### **I-405, SR520 to SR522 Stage 1 (Kirkland Stage 1)**

**Table of Contents**  
**I-405, SR520 to SR522 Stage 1**  
**Design Deviation Papers**

### Design Deviation #1

NB I-405 Superelevation Transition Location

Limited Access Design Deviation  
Exhibit 7  
Alt D – Modify SPUI  
Build New Ramp Within Existing Limited Access

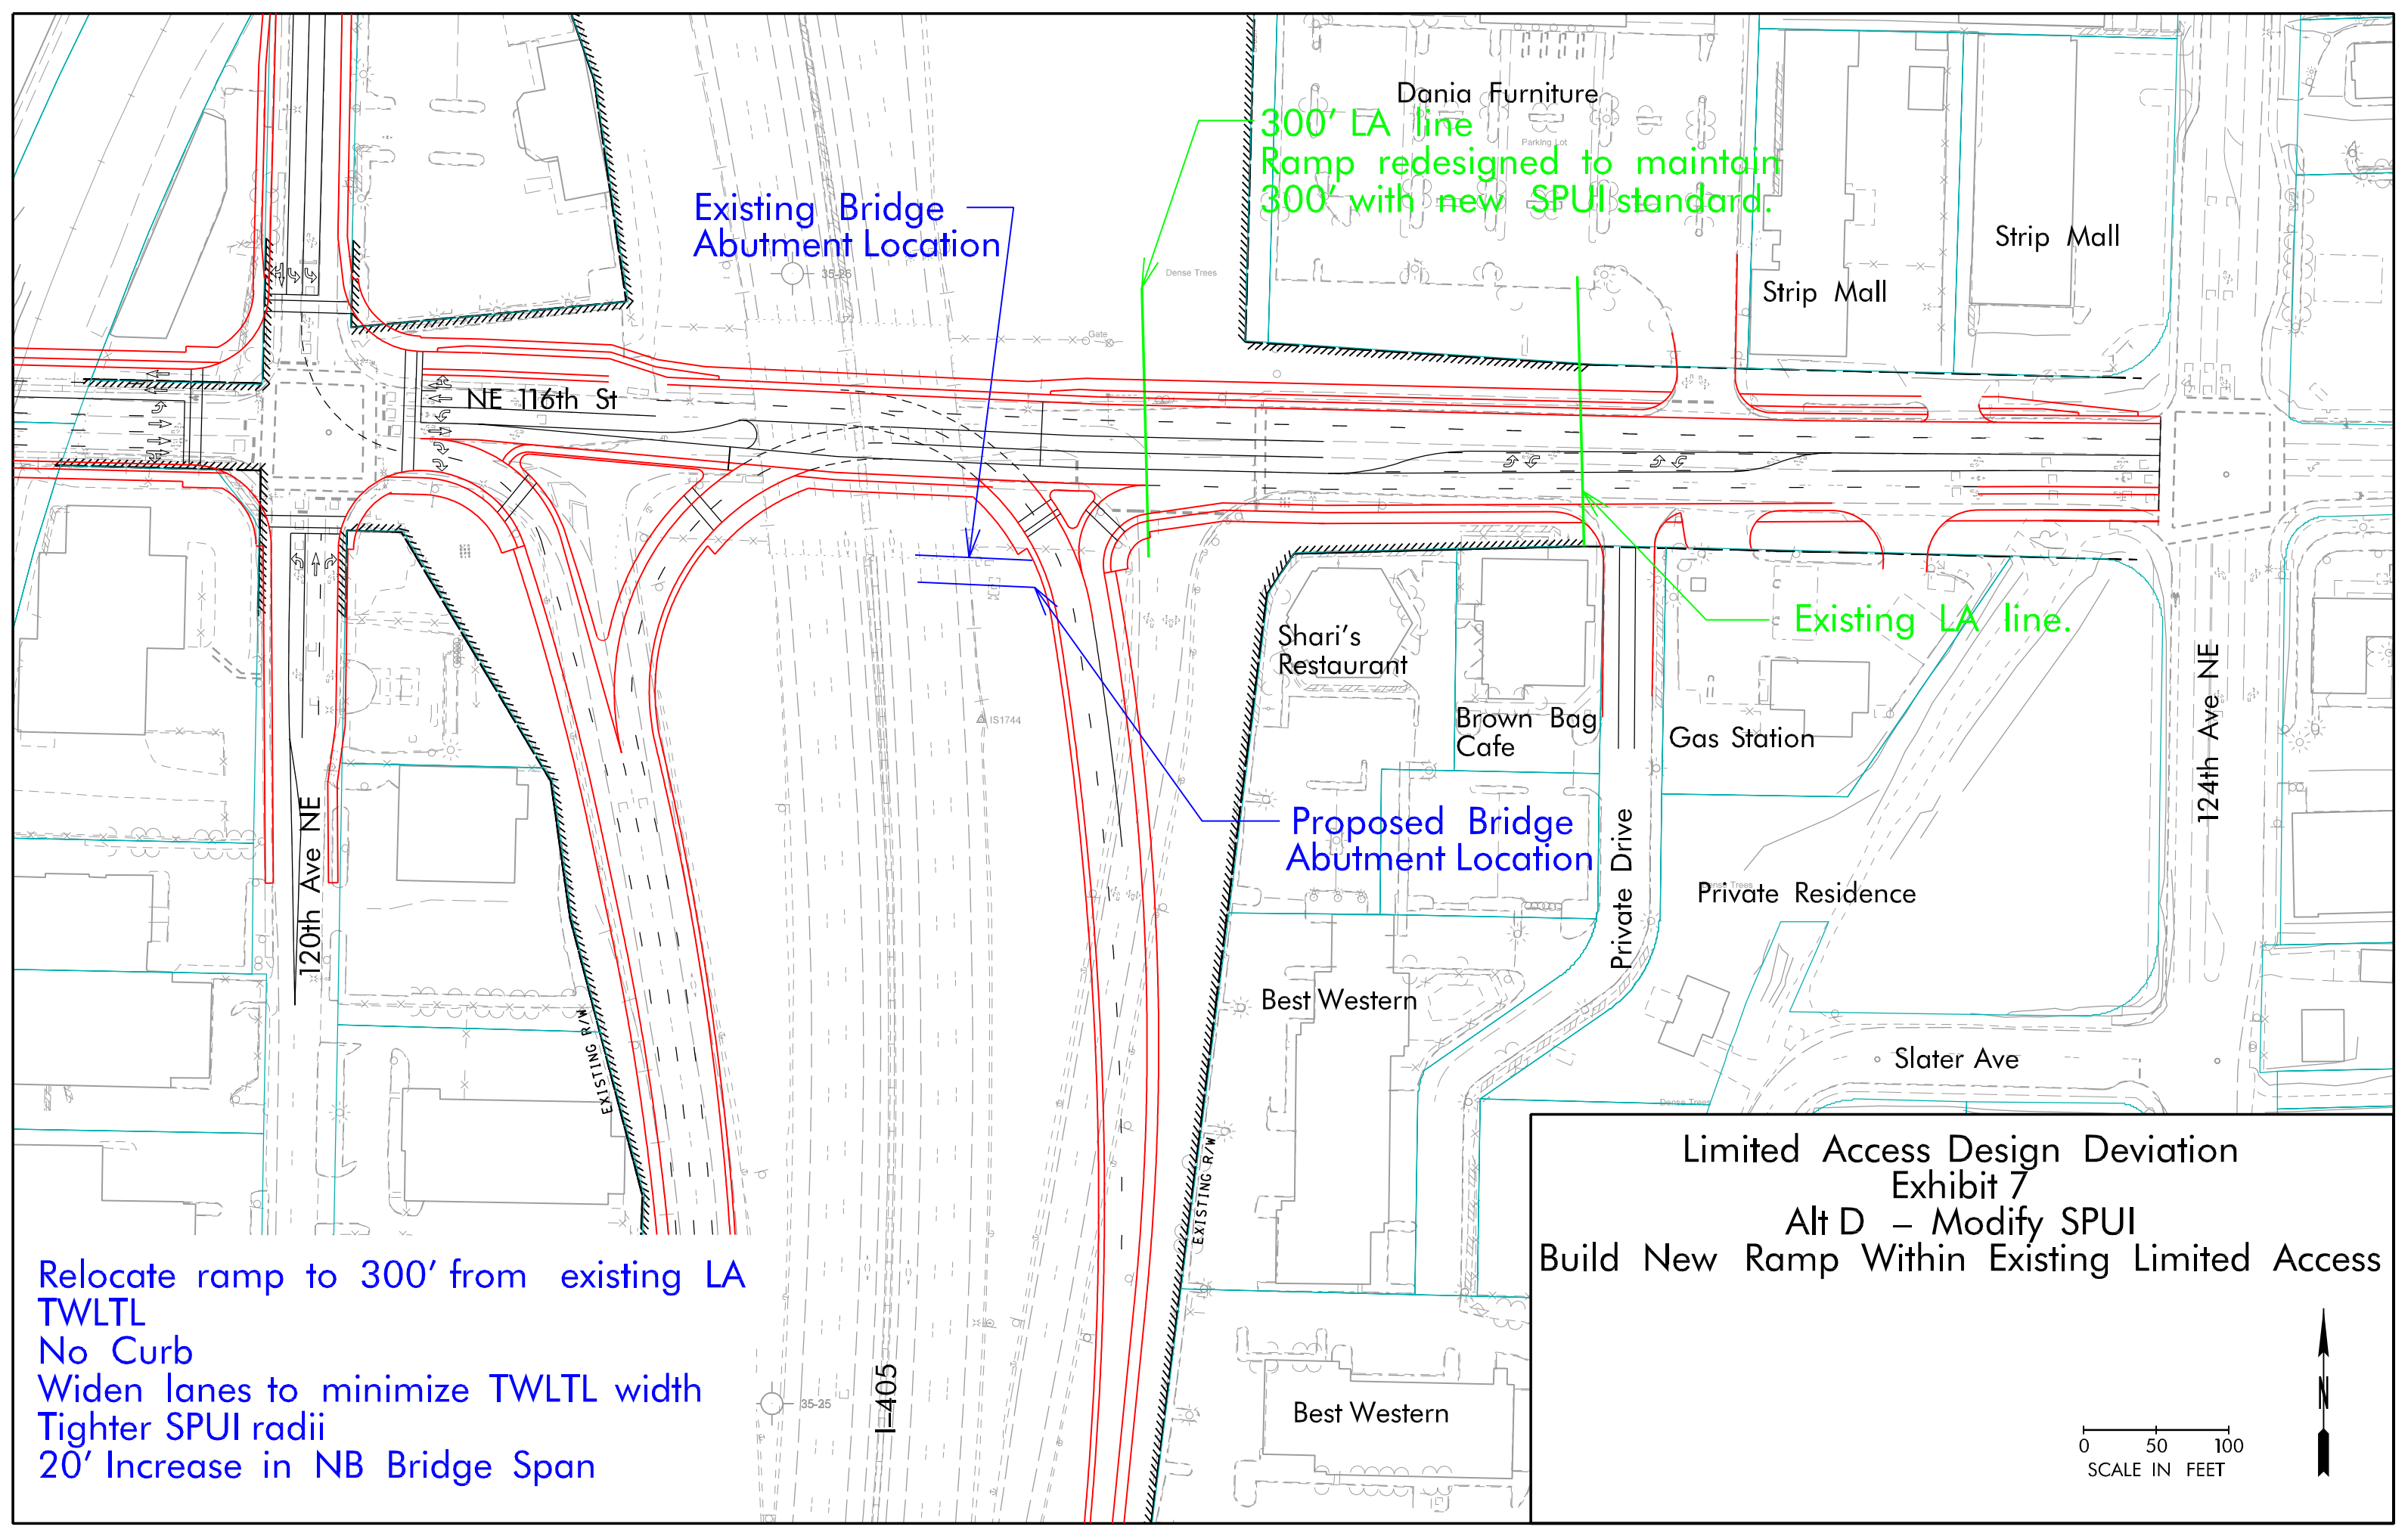
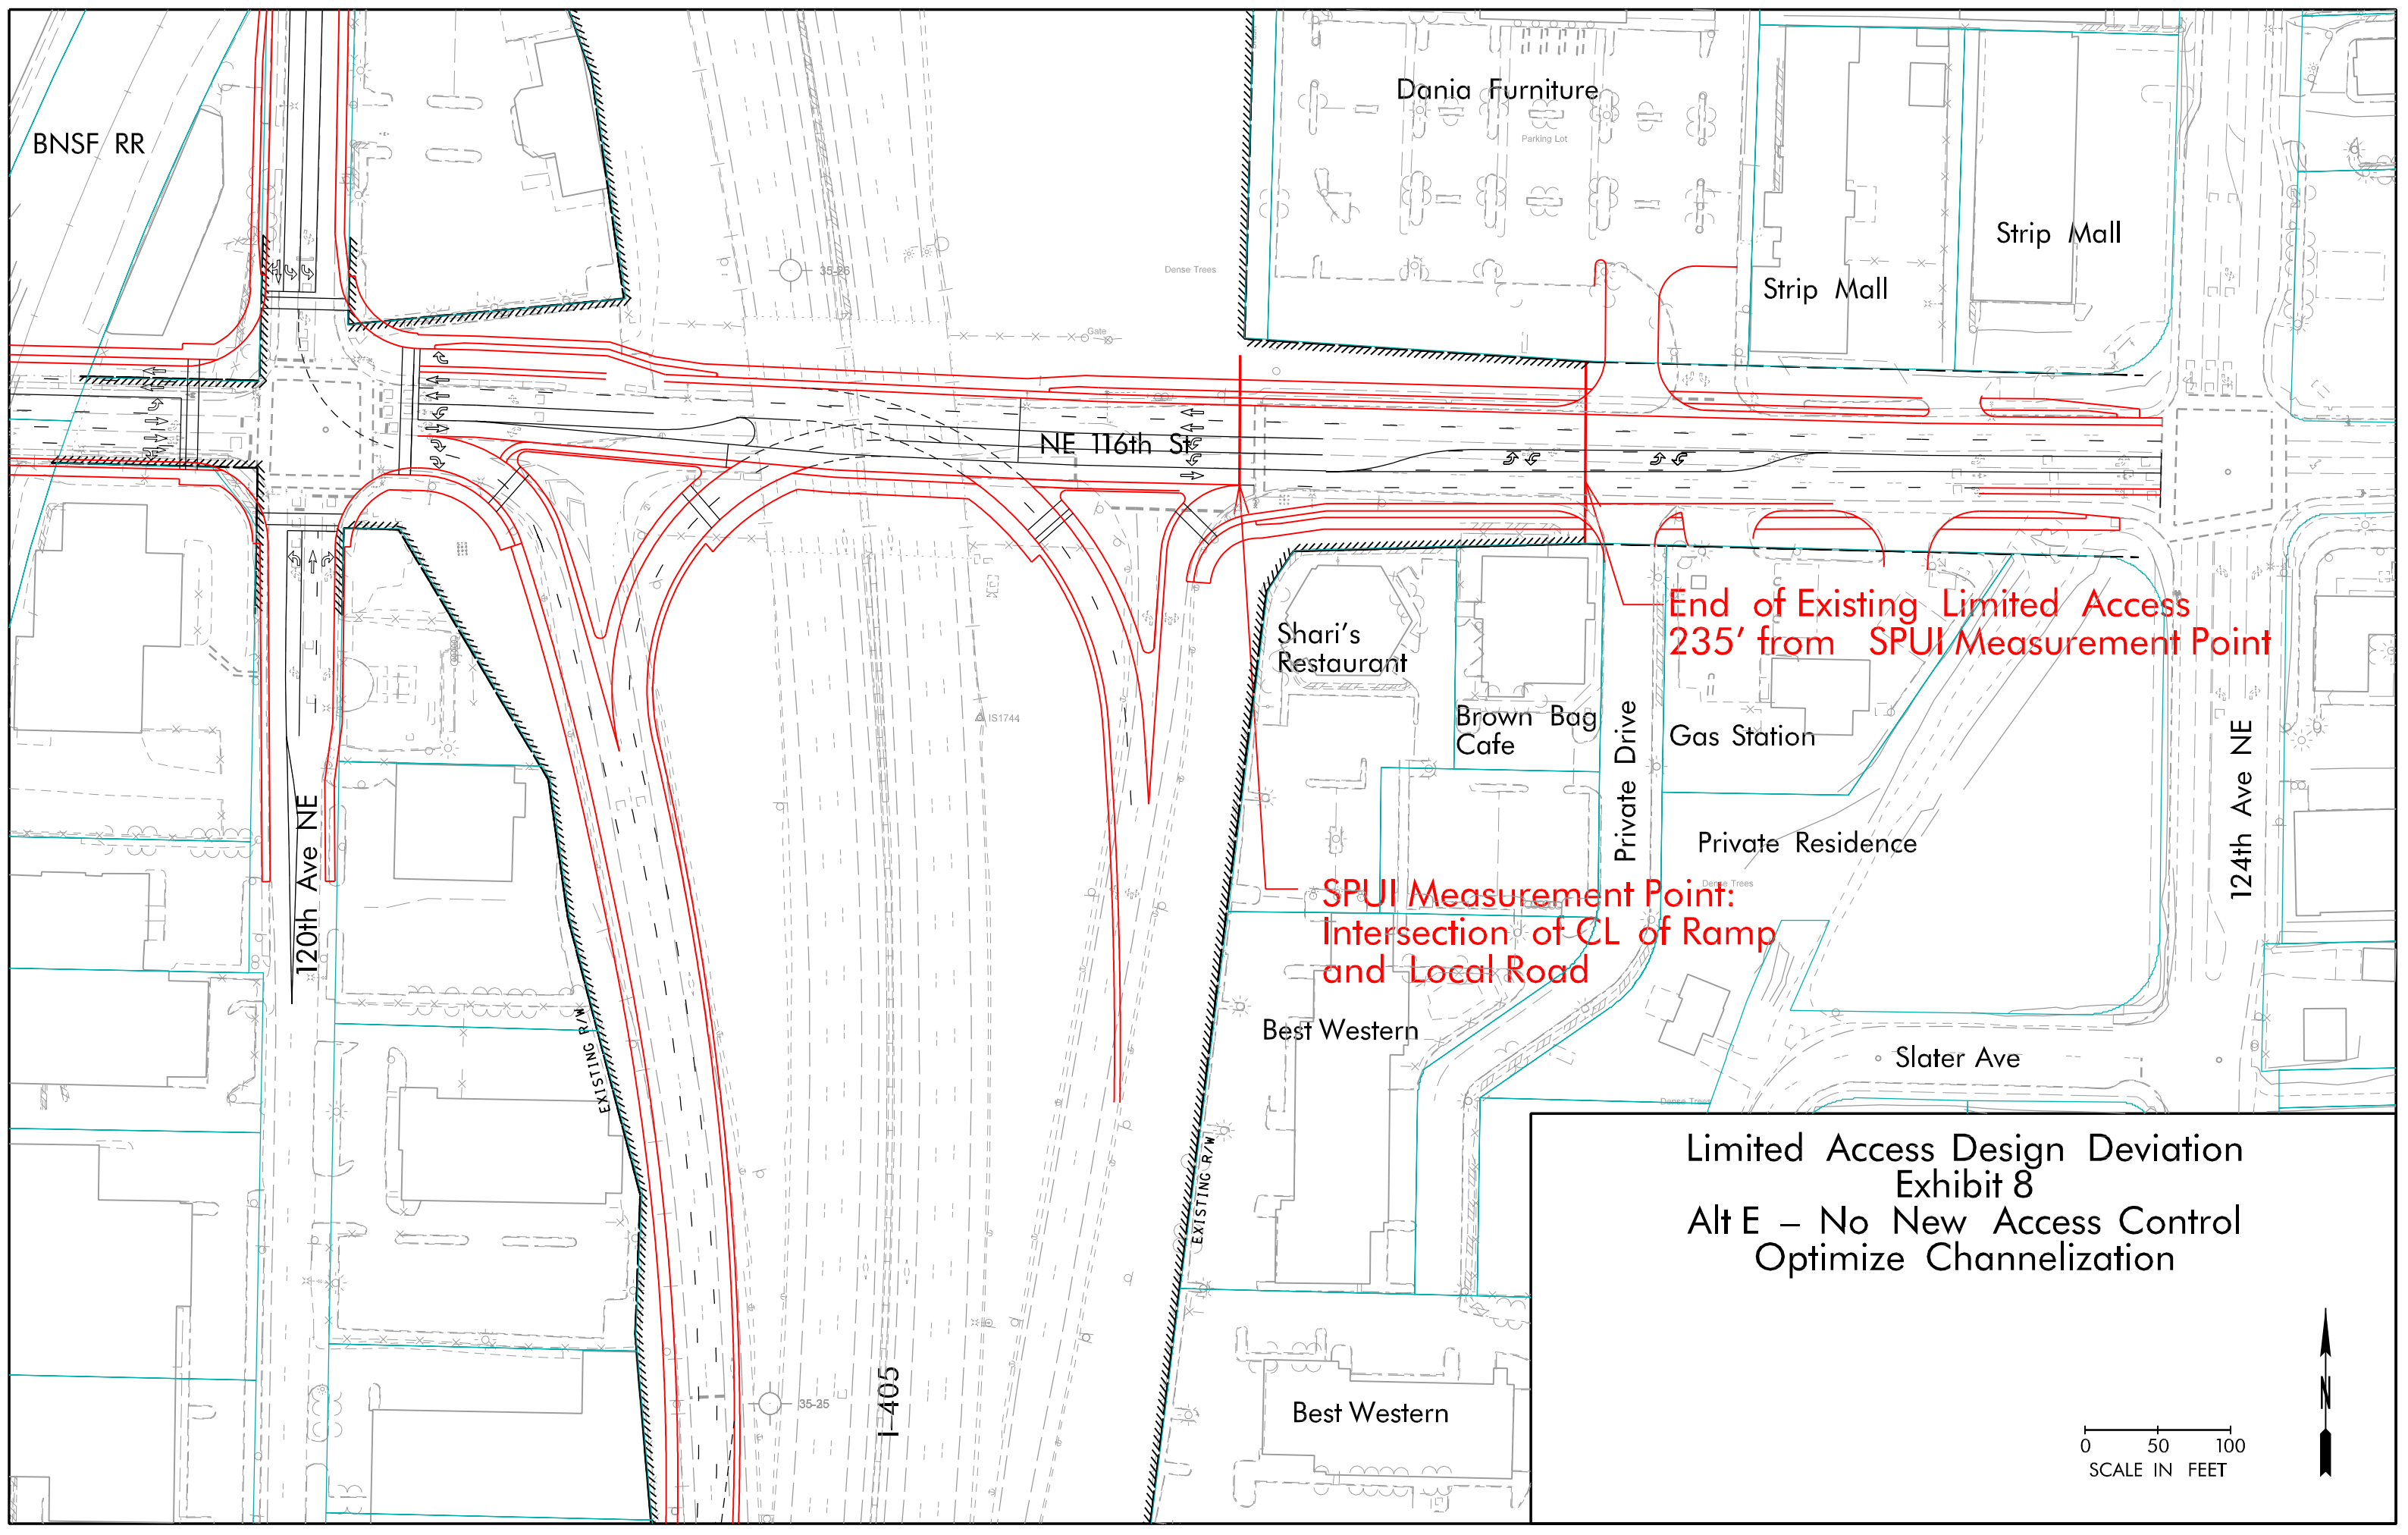
*Alternative D Modify SPUI-Build New Ramp within Existing Limited Access (Exhibit 7) –* This alternative will replace the existing half-diamond interchange with a tight half-SPUI interchange. The tighter half-SPUI ramp design would situate the reference point for limited access measurement in the same location as the existing configuration, eliminating the need to purchase additional access control. The radius for the left turning vehicles is the minimum necessary to meet the design speed through the SPUI (160 foot radius for a 25 mph design speed). The right turn pocket needs a 35 foot radius to match the limited access reference point, which is the design standard for a passenger vehicle. The right turn pocket would be widened and tapered to allow a WB-50 truck to complete the turn, though a WB-67 truck would encroach into the second lane to complete the turning movement.

Squeezing the SPUI ramp into the existing limited access area is not an optimal design for the NB off ramp. In order to build a ramp without increasing the span length of the bridge beyond its current limit, the storage length on the ramps would need to be decreased. Based on traffic models of design year (2030) conditions, this ramp configuration would not provide sufficient storage length for left turning vehicles, while queuing in the right turn lane could interfere with the operation of the SPUI. Increasing the span length of the bridge to increase the ramp storage length results in inefficiencies in the structure type and depth, an unpleasant appearance for the interchange, and the potential for pedestrian discomfort with the offset bridge abutments. Both the NB and SB bridges over NE 116<sup>th</sup> St. would need to be lengthened to meet the Context Sensitive Solutions (CSS) guidelines for the corridor. The total cost of lengthening the bridge span is approximately \$1 Million, including soft costs, inflation and a contingency.

Tightening the half-SPUI ramps to remain within the existing limited access (Alternative D, Exhibit 7) would align the measurement points for the proposed and existing limited access in the same place. The tighter half-SPUI ramp design would eliminate the need to purchase additional access control. This alternative was not selected because in order to provide sufficient storage on the off-ramp the NB bridge would have to be lengthened, increasing bridge cost significantly and degrading the operations of the interchange significantly. This alternative was approximately \$1 million.
